Addendum Number Five
To The Drawings and Specifications for
Juvenile Services Building
RFB Bid Number: 26-0021, Sedgwick County, Kansas

Issued: November 19, 2026

HANNEY & ASSOCIATES ARCHITECTS
1726 South Hillside, Wichita, Kansas

NOTICE TO BIDDERS
You are hereby instructed to include in your bids the following changes and/or corrections to the Drawings and Specifications for the **Construction of the New Juvenile Services Building at 881 S. Minnesota, Wichita, Kansas 67211.**

A FIRST FLOOR ELECTRICAL POWER PLAN - AREA "A"

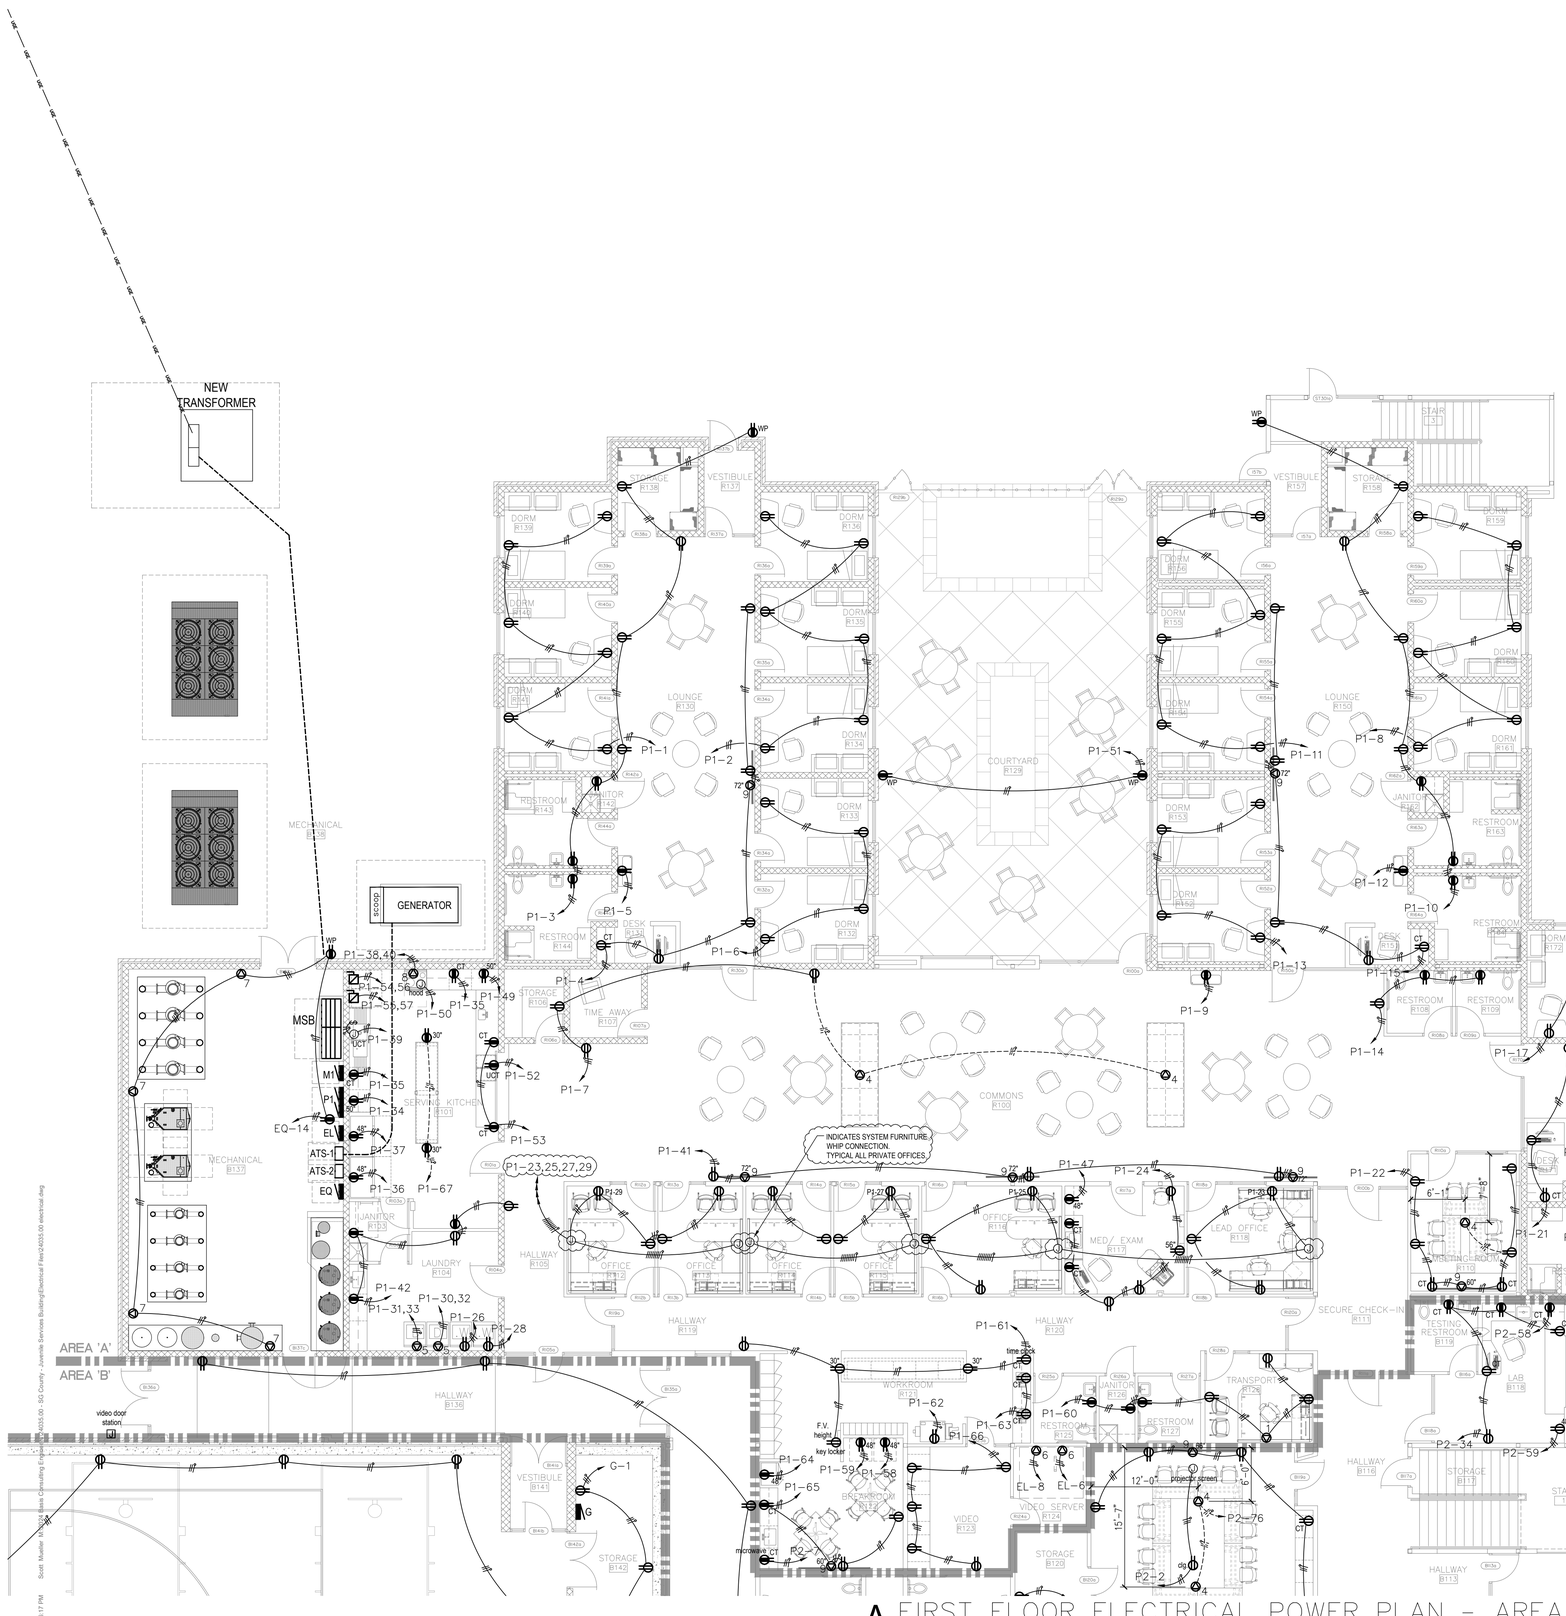
3.13 Sheet E2.1: See clouded changes on attached drawing.
Updated Power Plans to indicate system furniture connections in all private offices.

A FIRST FLOOR ELECTRICAL POWER PLAN - AREA "B"

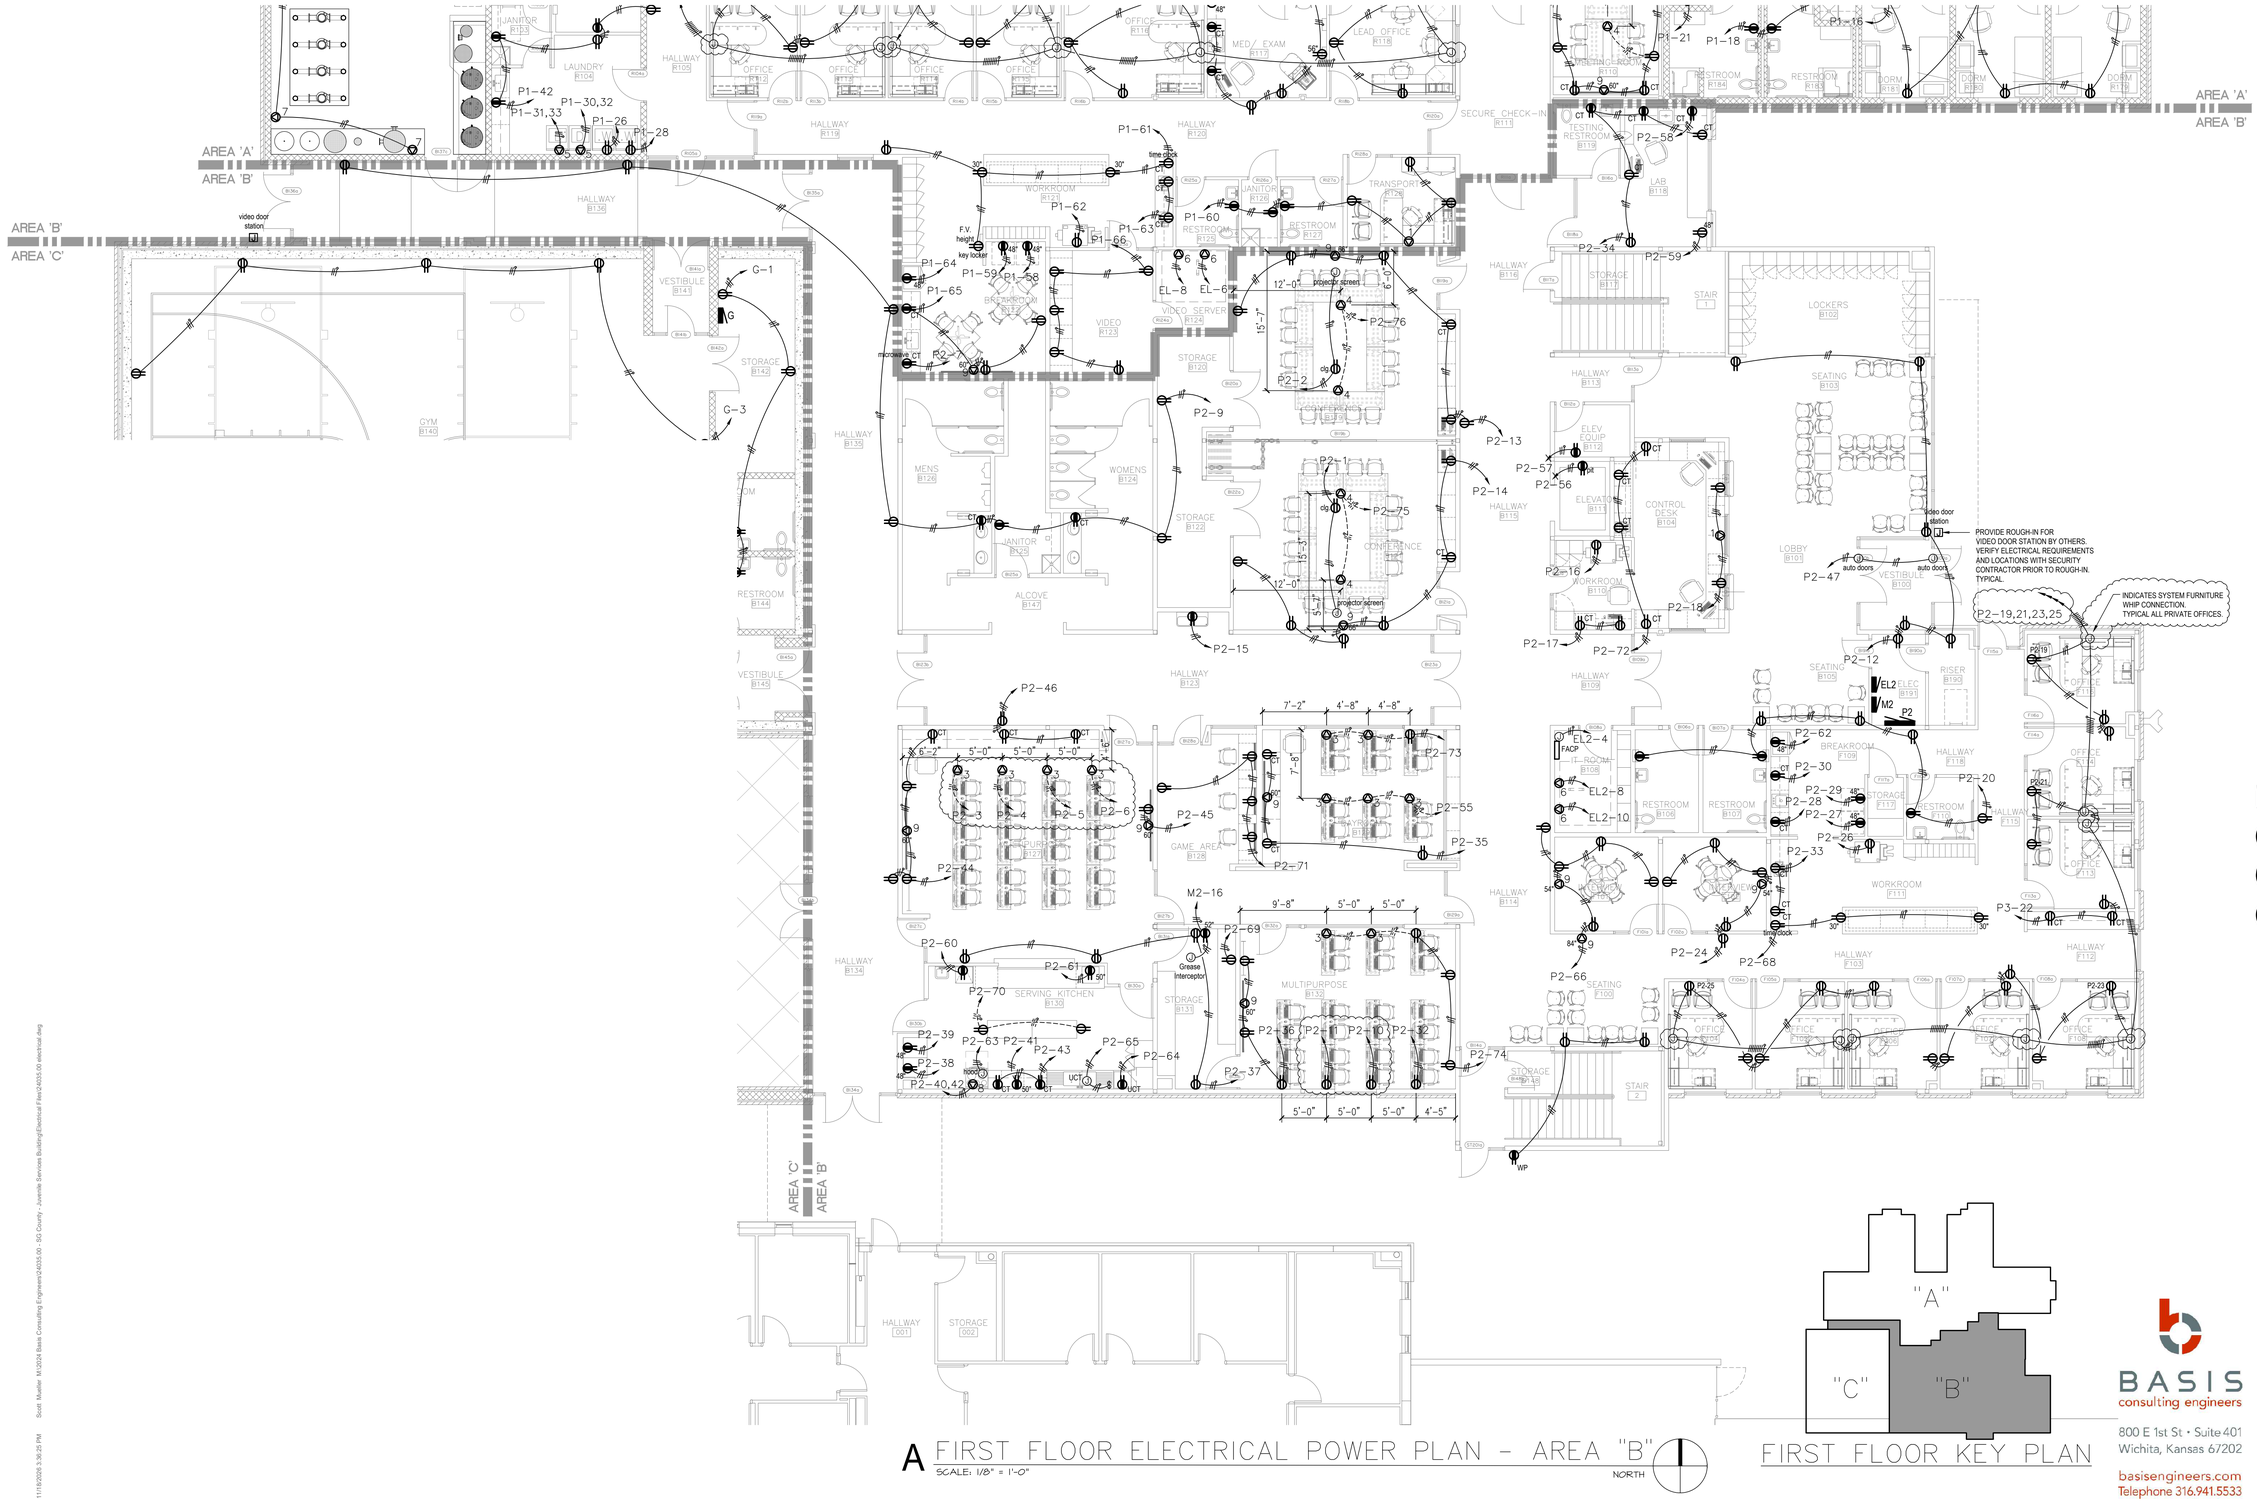
3.14 Sheet E2.2: See clouded changes on attached drawing.

a. Updated Power Plans to indicate system furniture connections in all private offices.

b. Multipurpose B127: Each floor box shall receive a dedicated circuit from Panel ‘P2’.

c. Multipurpose B132: Added two dedicated circuits from Panel ‘P2’.

A SECOND FLOOR ELECTRICAL POWER PLAN - AREA "E"
SCALE: 1/8" = 1'-0"

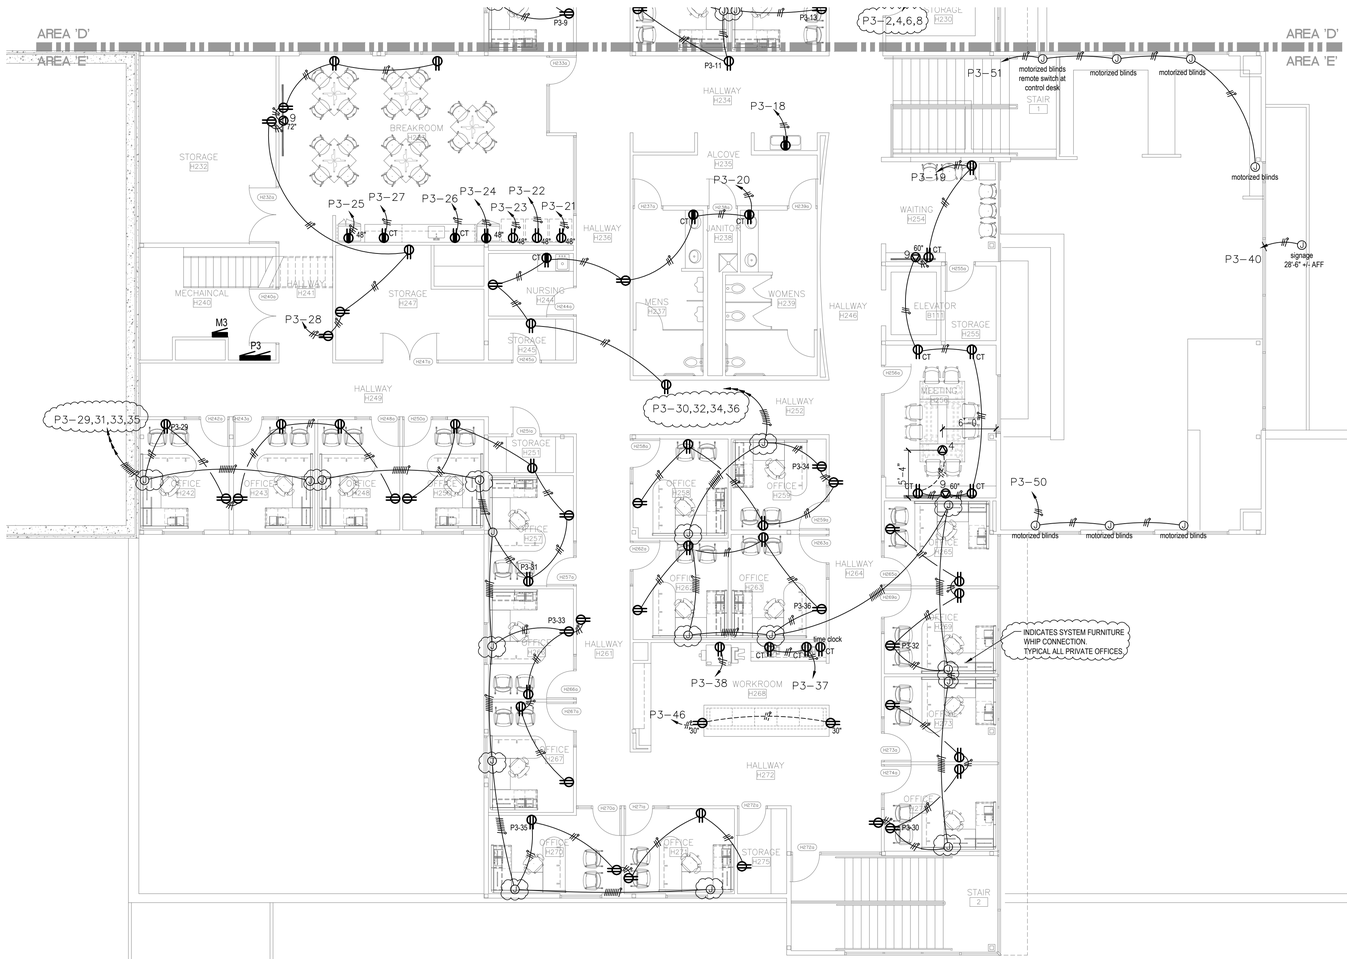
3.16 Sheet E2.5: See clouded changes on attached drawing.
Updated Power Plans to indicate system furniture connections in all private offices.
